E1465A-01

S E R V I C E N O T E

E1465A 16x16 Relay Matrix Switch

E1465A may fail to open/close relays because of a defective relay driver IC with date code 0325.

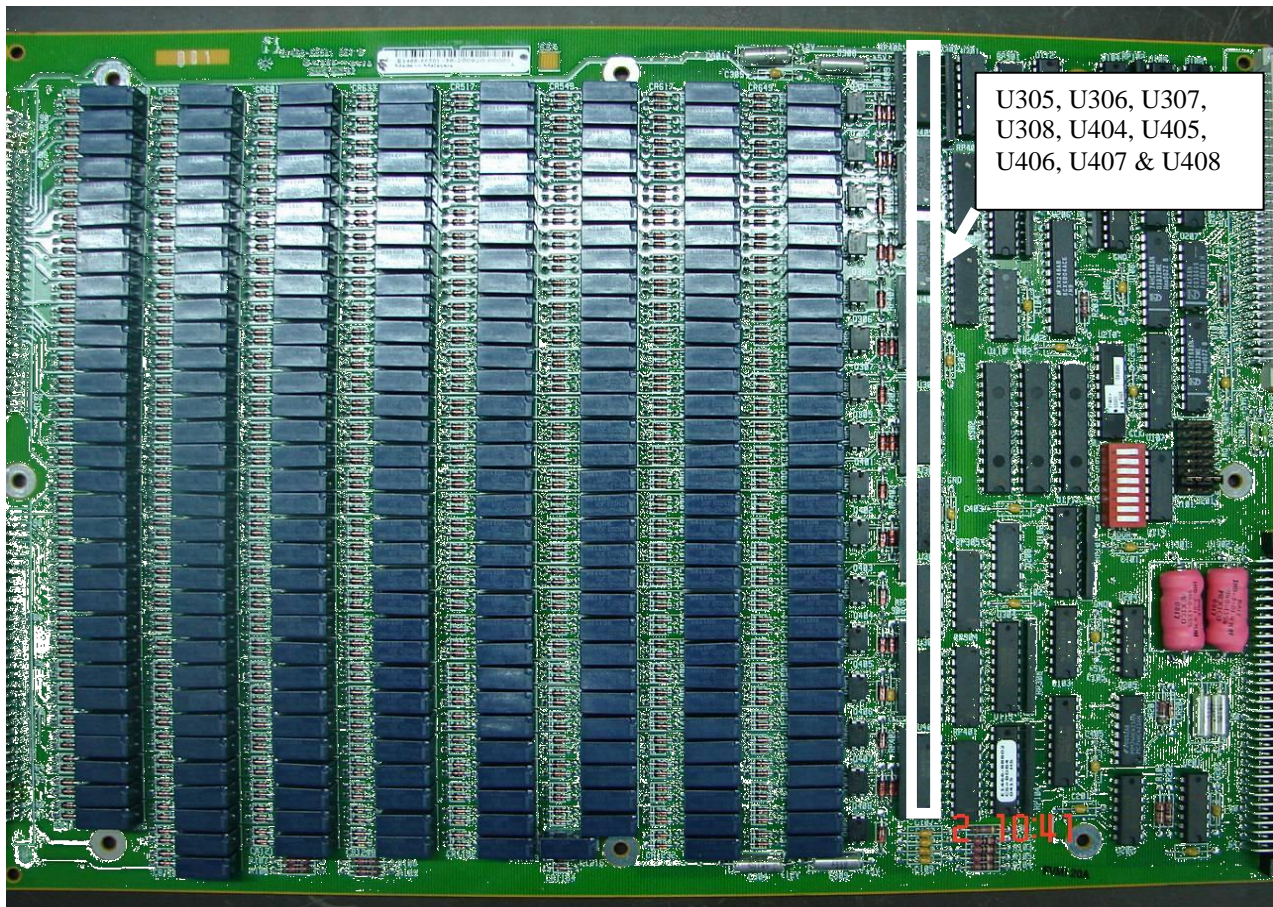
The relay driver ICs are U305, U306, U307, U308, U404, U405, U406, U407, and U408 which are the LTB part 5188-2550 for 1820-4599.

The bad date code is 0325. This date code has a higher than normal failure rate. Most failures have occurred in the first three months of usage. See the following pictures for part and date code location

Part Number	: E1466-66501
Location Impacted	: U305, U306, U307, U308, U404, U405, U406, U407 & U408
Reject Criteria	: DC 0325 on IC

A E1465A that fails to close or open it's relays and has the 0325 date code ICs should be replaced with a E1466-66701.
